October 16, 2009

This letter, sent on behalf of the U.S. Army (Mr. Paul Cloud), Jefferson Proving Ground (JPG), responds to a question raised by the U.S. Nuclear Regulatory Commission (NRC) during the 22 September 2009 teleconference. The teleconference included NRC Technical Staff, the Army's Radiation Safety Officer (RSO, Paul Cloud), and four technical staff from Science Applications International Corporation (SAIC). Specifically, this letter addresses a question concerning the spatial distribution of proposed sampling locations where soil was collected to conduct partition coefficient ( $K_d$ ) testing. Table 1 lists all of the proposed samples, soil type groupings, types of sorption tests, site I.D.s/depths, and concentrations. The site I.D.s are the names assigned to the locations where the samples were collected and are shown in Figures 1 and 2.

Figure 1. Penetrator Sample Locations

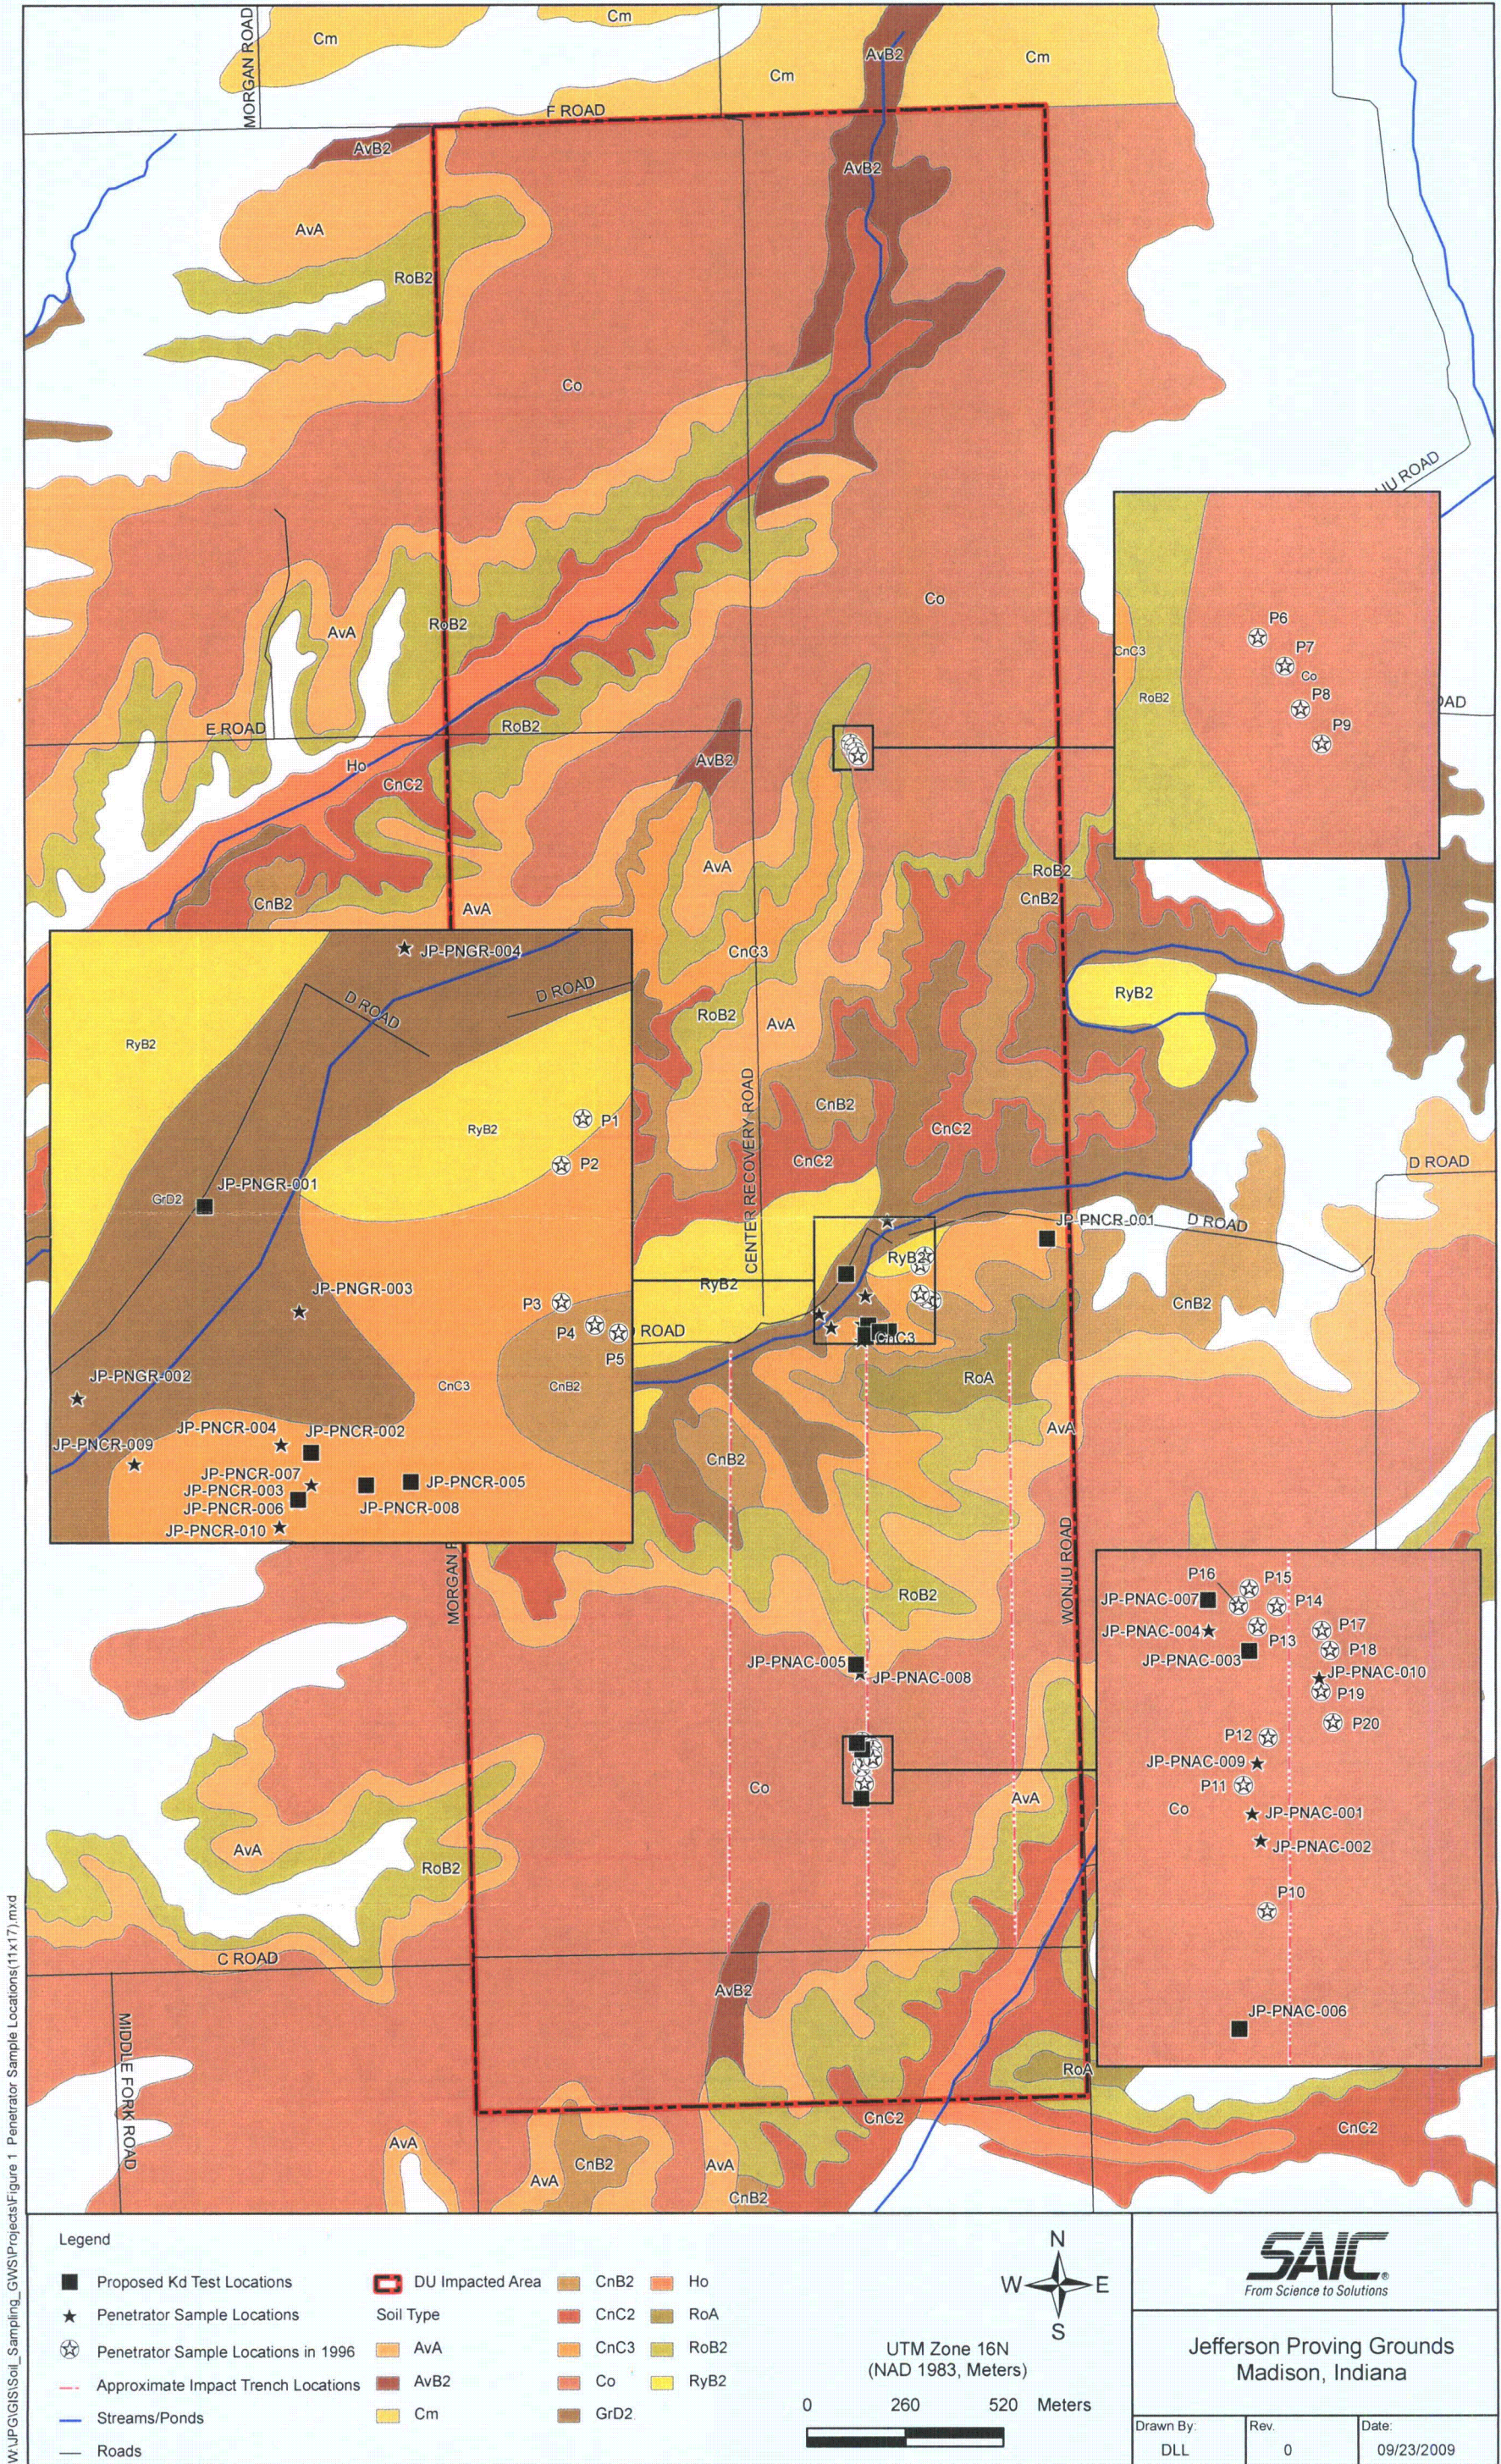
Figure 1 shows the locations where depleted uranium (DU) penetrators were collected in October 2008. Eighteen samples (identified with ten black squares in Figure 1) signify the locations where soil also was collected to assess desorption of uranium from soil using partition coefficient ( $K_d$ ) testing. The spatial distribution of proposed locations spans the widest area available from north to south and east to west where penetrators were collected in October 2008. It should be noted that penetrators are not distributed throughout the entire 2,080-acre DU Impact Area. Instead, they are primarily located in close proximity to firing lines running south to north between C Road and Big Creek as shown in red in Figure 1. Most penetrators are located near the trench formed by the middle firing line, which is associated with the 500 Center Firing Position, since it was used to fire approximately 90 percent of the DU penetrators into the DU Impact Area. Due to the difficulty in locating DU penetrators and the explosives safety hazards present throughout the DU Impact Area, the focus of the search was limited to the areas where penetrators would most readily be found as described above. It should be noted that the criteria defined in Field Sampling Plan (FSP) Addendum 7 were to locate penetrators in all the soil type groupings and provide a broad range of concentrations. Since the recommended sample locations ranged in concentrations from approximately 15 to 29,000 pCi/g and samples were collected from each of the soil type groupings (8 from Avonsburg/Cobbsfork, 8 from Cincinnati/Rossmoyne, and 2 from Grayford/Ryker), this objective was met for the samples recommended for desorption testing.

Figure 2. Background Sample Locations

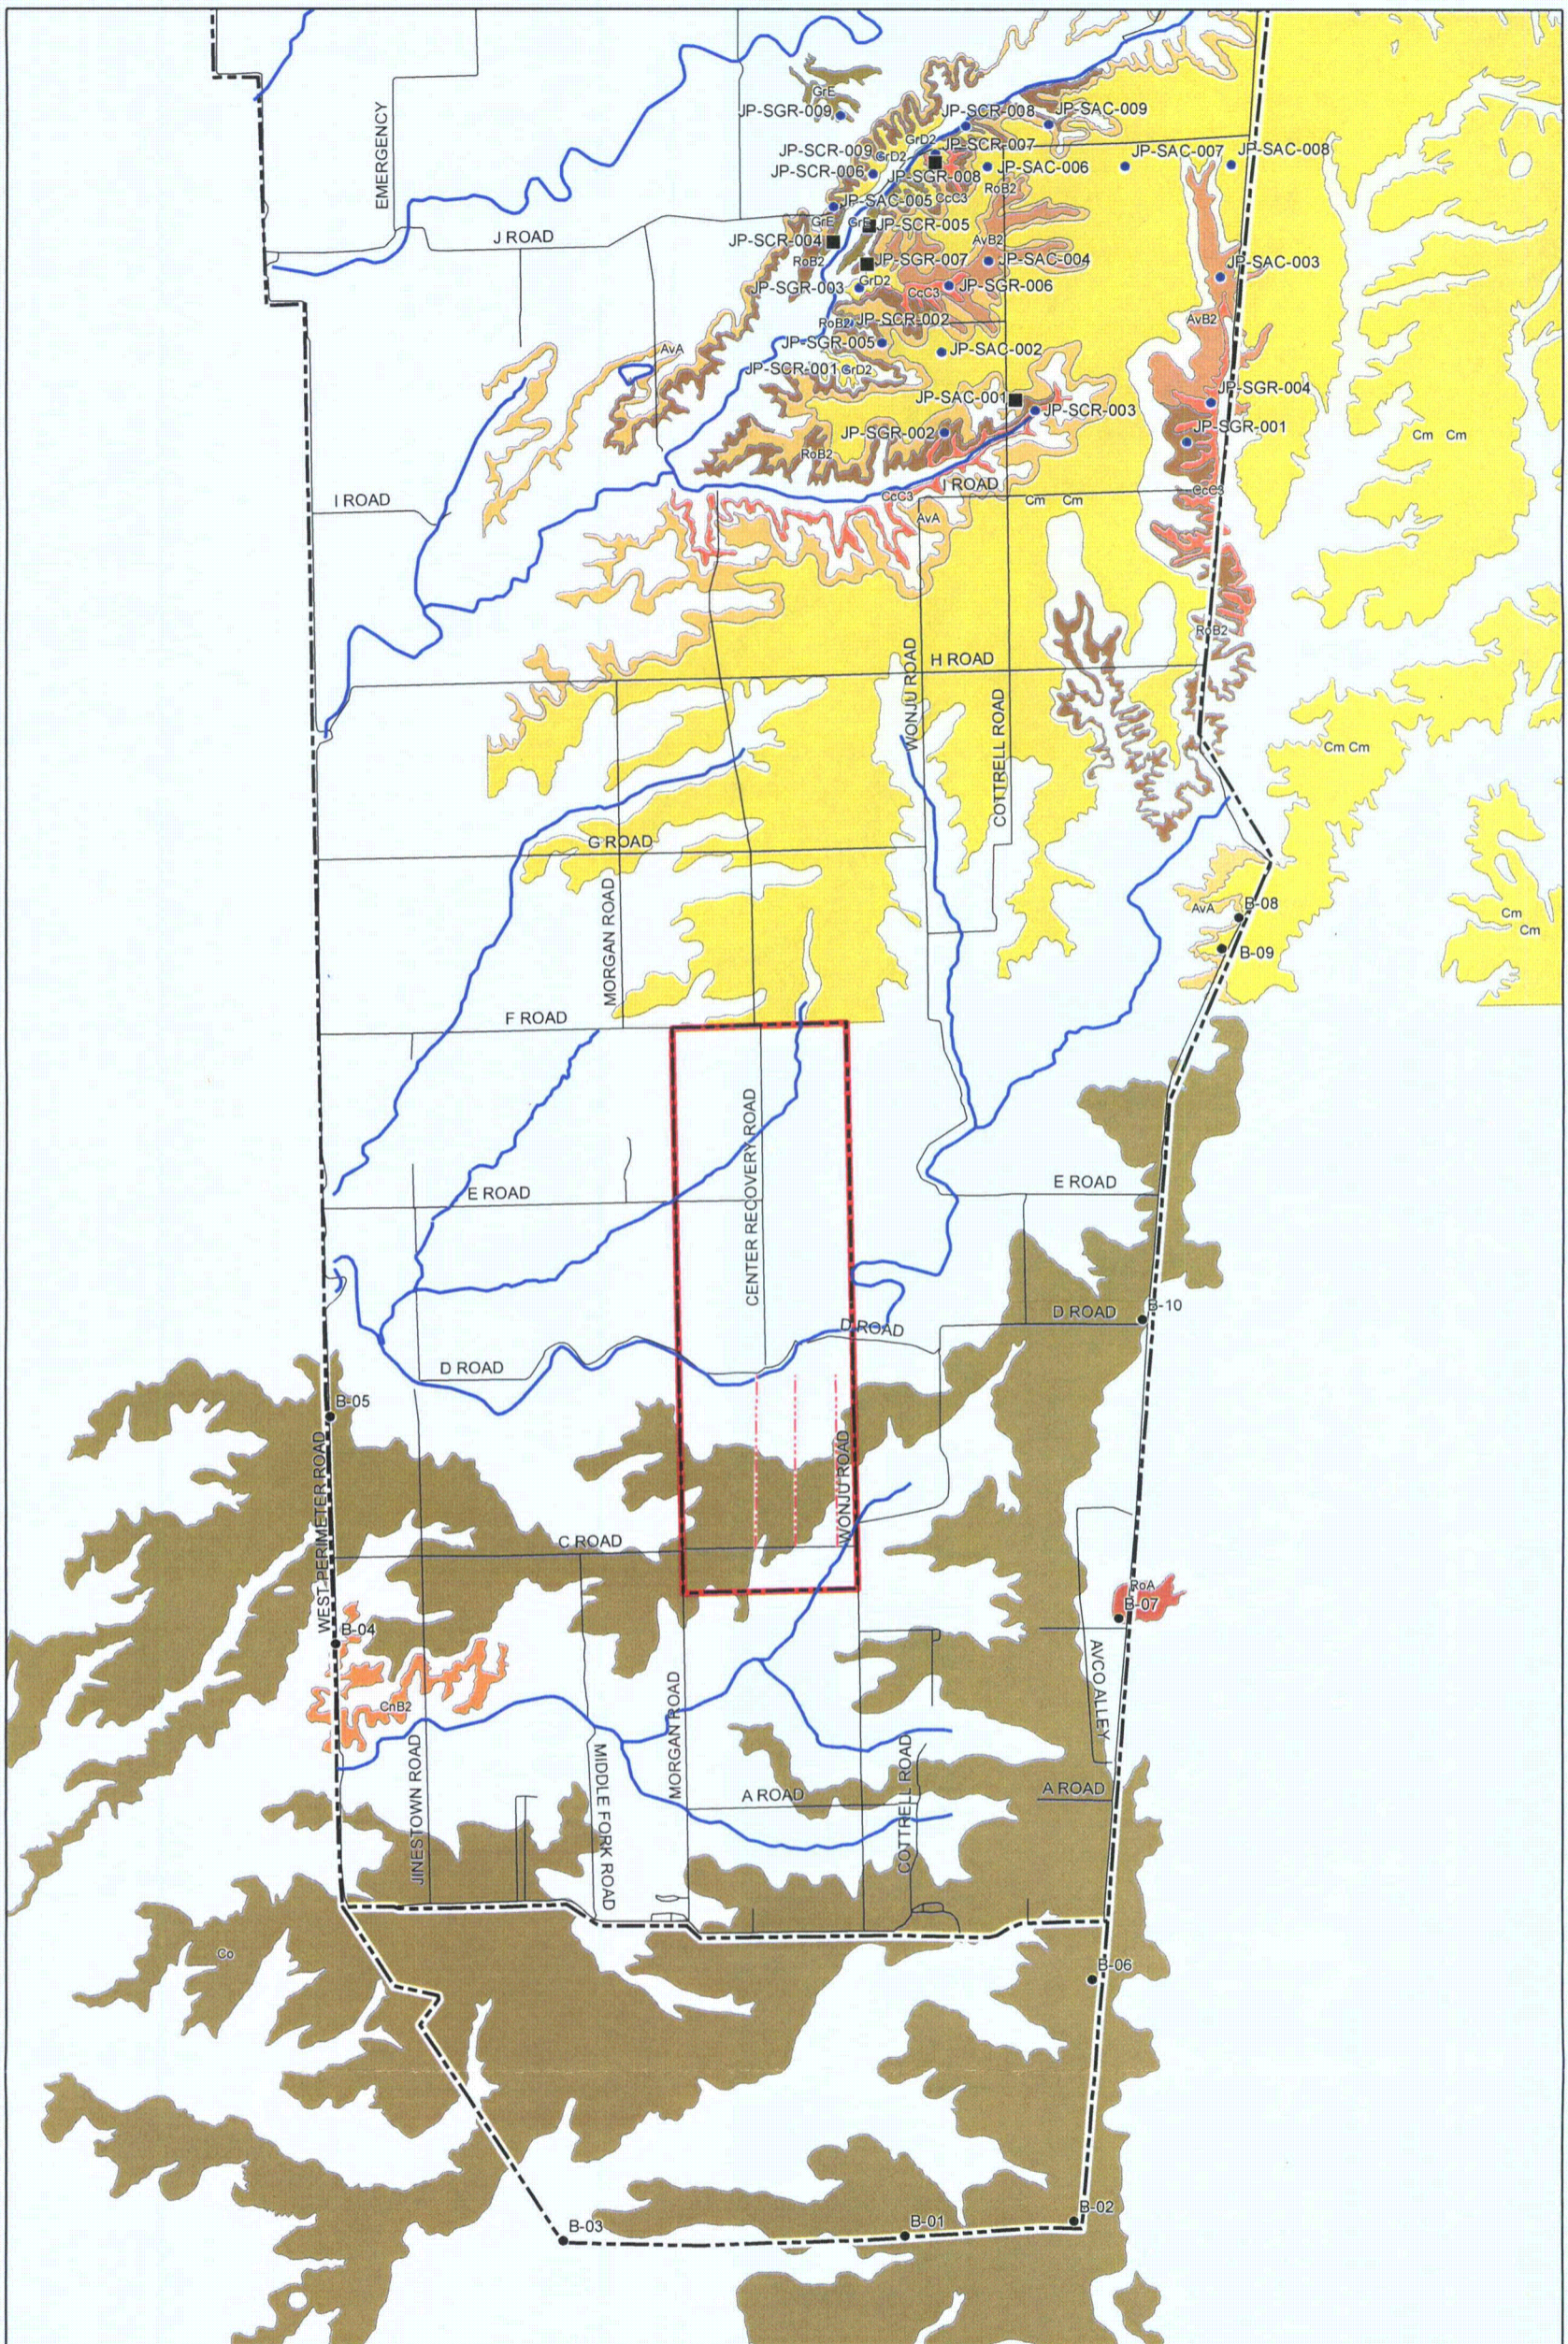
Figure 2 shows the locations of where background soil samples were collected. Six samples (identified with five black squares in Figure 2) signify the locations where soil also was collected to assess adsorption of uranium to soil using partition coefficient ( $K_d$ ) testing. The spatial distribution includes 4 proposed locations near Little Graham Creek and 2 proposed locations further east and south. Like the samples proposed for desorption testing, FSP Addendum 7 included objectives for these locations to include samples from each of the predominant soil type groups and with concentrations consistent with background. As these samples were collected from the 3 predominant soil type groupings (2 each from Avonsburg/Cobbsfork, Cincinnati/Rossmoyne, and Grayford/Ryker) and concentrations were all relatively low (approximately 1.4 to 1.9 pCi/g), this objective was met for the samples recommended for adsorption testing.
